41 Hutchins Drive

**CITY OF PORTLAND, MAINE  
DEVELOPMENT REVIEW APPLICATION  
PLANNING DEPARTMENT PROCESSING FORM  
DRC Copy**

**Amendment to Plan - Woodard & Curra**

**From:** "Kenneth Volock" <kvolock@woodardcurran.com>  
**To:** <terrigo@wilbursmith.com>, <JF@portlandmaine.gov>  
**Date:** 8/23/2006 9:06:58 AM  
**Subject:** Revised Woodard & Curran Entrance

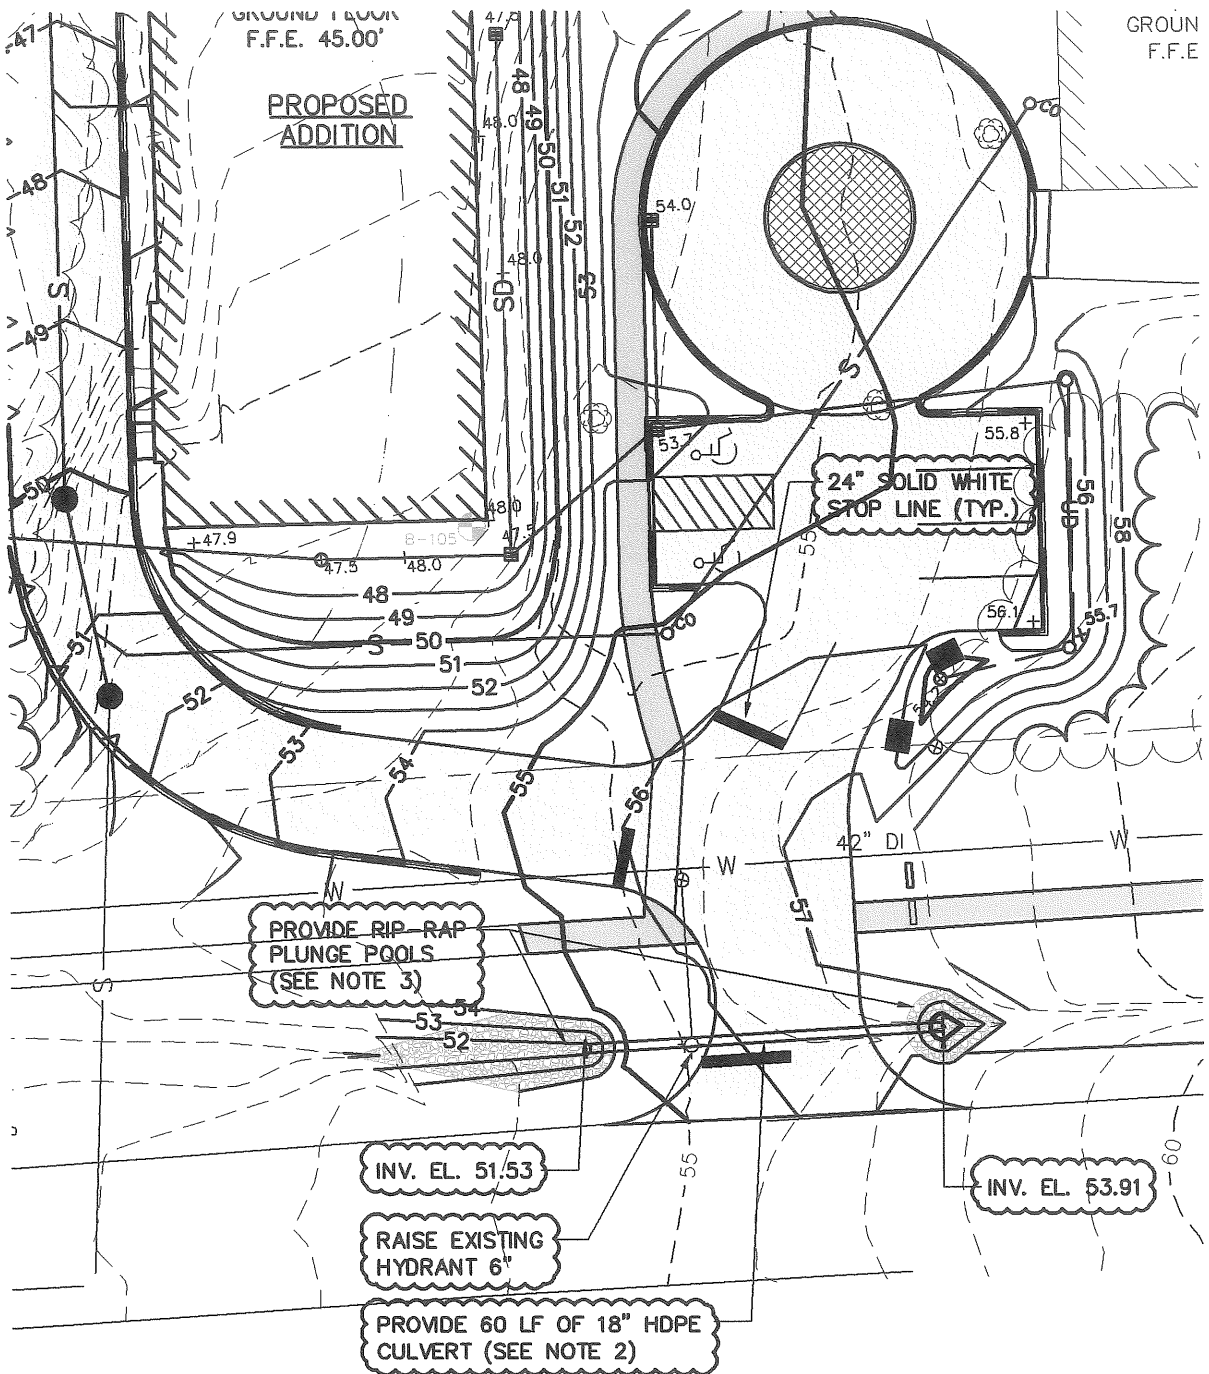
Please see the attached sketch which shows a revised main entrance for the Woodard & Curran building. The present proposed layout is based on conversations between Tom and myself. The entrance and exit lanes are each 15' wide to accommodate larger vehicles turning into and coming out of the access drive that goes around to the rear of the building.
